**From:** Cash, John [John.Cash@ur-energyusa.com]  
**Sent:** Friday, July 23, 2010 11:37 AM  
**To:** Bjornsen, Alan  
**Subject:** RE: More Questions

**LOST CREEK ISR, LLC**

**Re: Submittal of Wildlife Monitoring and Protection Plans**

**FIGURE OP-A6-2**  
**SAGE GROUSE LEKS - 2009**  
 Lost Creek Permit Area  
 Issued For: WDEQ and USFWS  
 Issued/Revised: 9.25.09 Drawn By: HN  
 Drawing No: WDEQLQD FIGOP-A6-2  
 0 1 Mile  
 1 inch = 4,000 feet

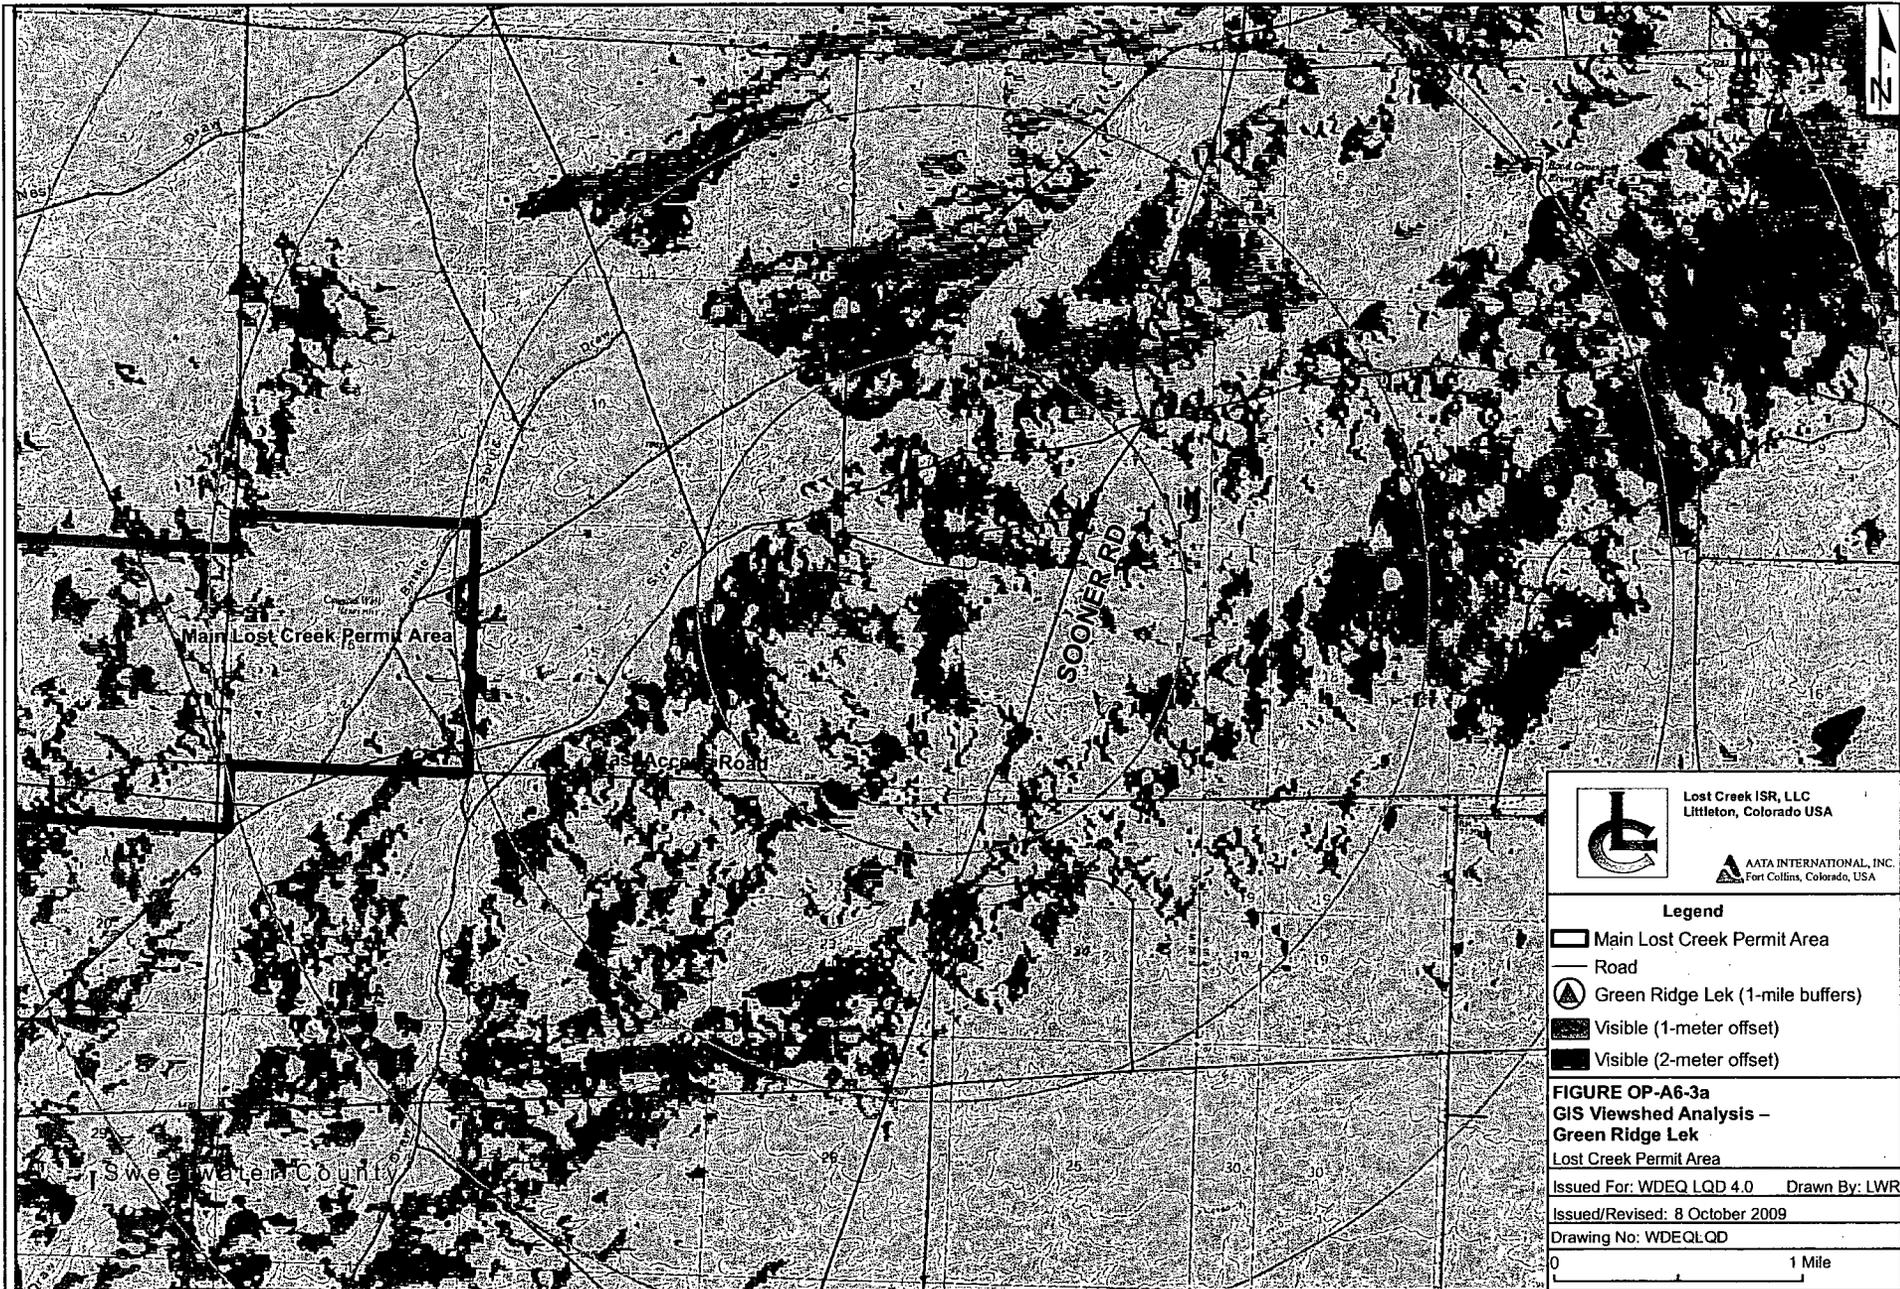
Thank you, John. But, I have a question – On Fig. OP-A6-2, you show leks with 0.25-mi exclusionary boundaries, and 2-mi buffers. Since Lost Creek is in a Core Breeding Area, shouldn't the boundaries be 0.6-mi (exclusionary) and 4-mi (buffer)? Please explain this disparity. Thanks.

You are partly correct. The exclusionary boundary for "occupancy" is 0.6 miles. There are no 4 mile buffers per se. However, these stipulations were not approved by the Sage Grouse Implementation Team until June 30 and we have not amended the application yet to include the latest changes in the stipulations. We probably won't amend the application until the Governor signs a new executive order causing the stipulations to go into effect. Regardless, we commit to abiding by the recommendations of the Sage Grouse Implementation Team.
